SUBJECT: Duke Energy Corporation Oconee Nuclear Station, Unit 3, Docket Nos. 50-287 McGuire Nuclear Station, Unit 2, Docket No. 50-370 Catawba Nuclear Station, Units 1 & 2, Docket Nos. 50-413, 50-414

> Response to Request for Additional Information Relief Request 04-GO-002 (TAC NOS. MC3804, MC3805, MC3807, MC3810)

Attachment 1 RAI Questions and Responses for Relief Request 04-GO-002

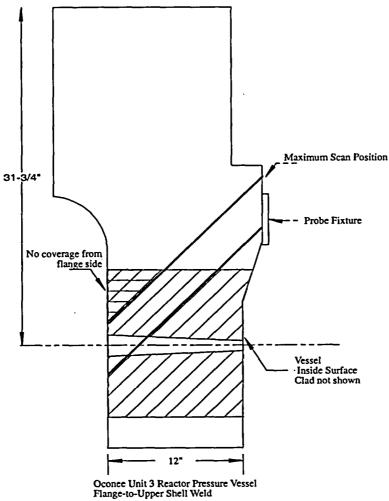
The estimated volumetric coverage for the reactor upper shell-to-flange weld at ONS-3 using the proposed alternative is 72.6 percent, which is less than the required 90 percent coverage. Please confirm whether the most critical areas susceptible to degradation (the weld + heat affected zone) will be covered using the proposed alternative.

Although this particular exam (UT from vessel wall) results in limited coverage of 72.6 percent, please note that this exam is only considered as 50% of the total examination requirement specified in ASME Section XI, Table IWB-2500-1, Category B-A, Item B1.30. Duke uses the deferral allowed by the code table to perform two partial exams, flange face and vessel wall, to be conducted at different times within the 10-year interval. Table notes (3) and (4) provide details to the user on how to implement the deferral. The flange face partial exam was previously performed during the first inspection period while the vessel wall partial exam is scheduled for the third inspection period.

In Duke's Response 2a above, the table data shows coverage of the weld and heat affected zone to be 100% by the flange face partial exam and 72.6% by the vessel wall partial exam.

The vessel flange partial exam is unaffected by the use of the proposed alternative; however, the following particular limitations were identified for the vessel wall partial exam.

- 1. A limited coverage area begins at a point 1.125 inches from the weld edge on the outside surface of the flange and continues upward for a distance of 5 inches along the base material (flange forging) toward the flange seal surface. This condition exists 360° around the vessel. It is caused by a flange inside surface geometry change that limits the scanning probe from being positioned high enough to cover the entire inspection volume. The limitation is shown as a triangular area on the Attachment 2 cross-section sketch.
- 2. There are four clad patches above each main coolant loop nozzle that limits coverage of the outer surface of the weld and heat affected zone for 14.4 inches of the weld length above each nozzle. This limitation only applies to the axial scan from below the weld. The cumulative length of the limitation is 57.6 inches.
